Re: PI 9912-155, Interpretation for RZ/FDP 1998-SU-057, Timber Ridge

Re: *Timber Ridge*
RZ 1999-SU-057

Concept Sketch

TIMBER RIDGE

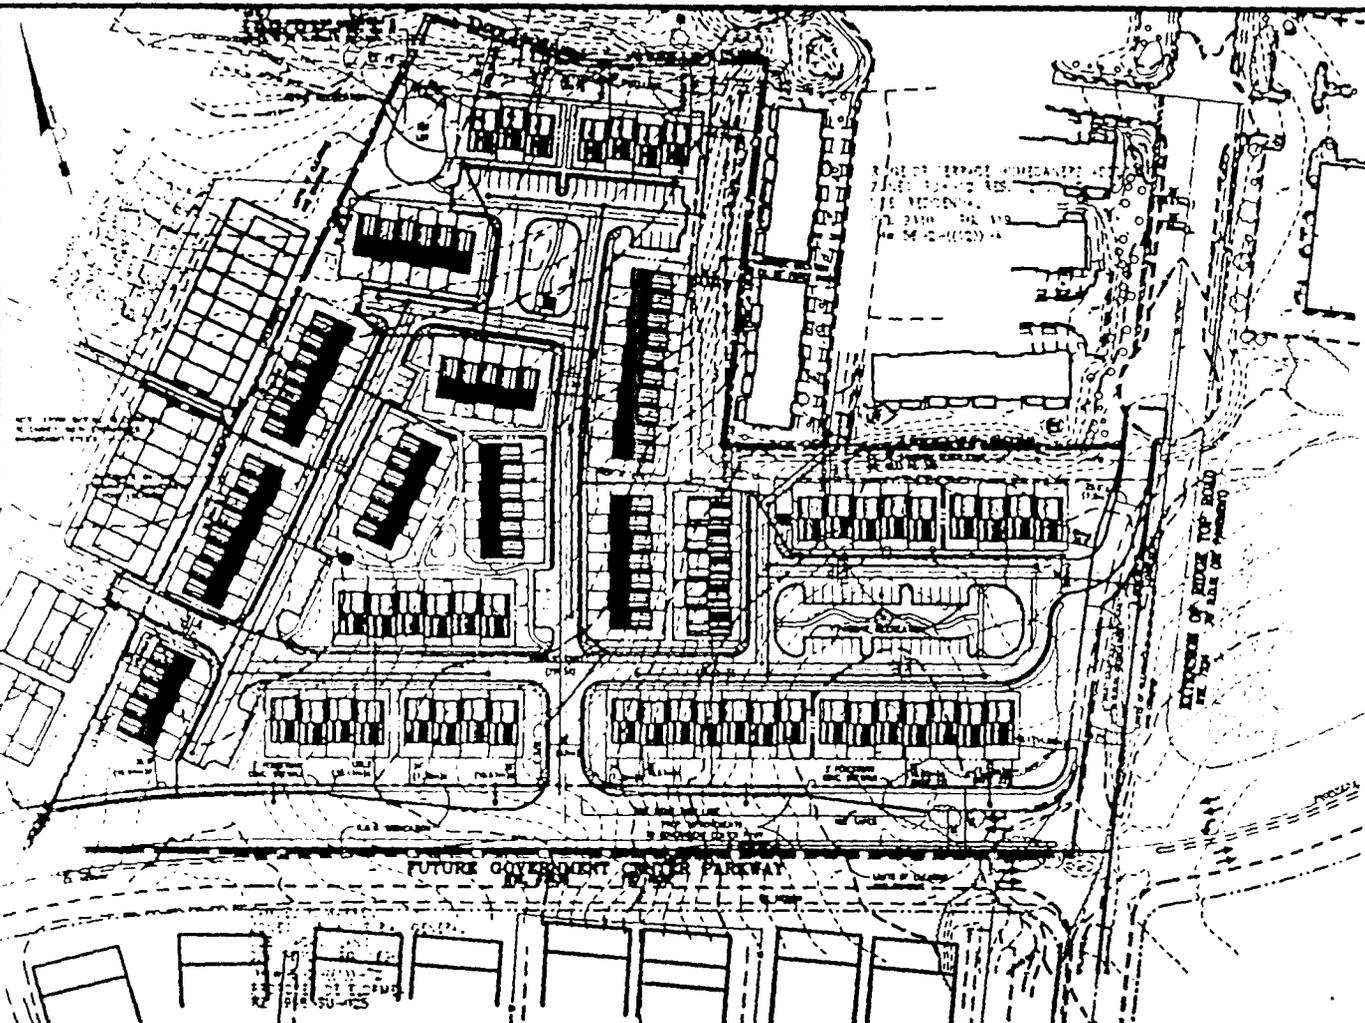
There are two styles of market rate units within the development. One is a 16 feet wide unit" and the other is a 24 feet wide unit. The purpose of the sketch is to move the 16 feet wide units along Government Center Parkway and to position the 24 feet wide units internally. There is no increase in density and the basic road configuration shall remain the same in general.

You'll note that the front parking island becomes more narrow, but the rear parking island has been reconfigured, is larger and more efficient. Additionally, there is more open space behind units within the development where the 24 footers have replaced the 16 footers since they have lots with less depth. Please note that all perimeter setbacks shown on the CDP/FDP will be honored. Tabulations have been provided on the sketch for your information.

116 (116)	=	Units Total
14 (14)	=	ADU's
58 (60)	=	16' townhomes
44 (42)	=	24' townhomes
Parking Area Spaces		= 87 (82) spaces

It is my determination that the proposed reconfiguration of the units and the revisions to the parking lot layout are in substantial conformance with the approved conceptual/final development plan. This determination has been made in my capacity as the duly authorized agent of the Zoning Administrator. If you have any questions regarding this interpretation, please feel free to contact Susan Johnson at (703) 324-1290.
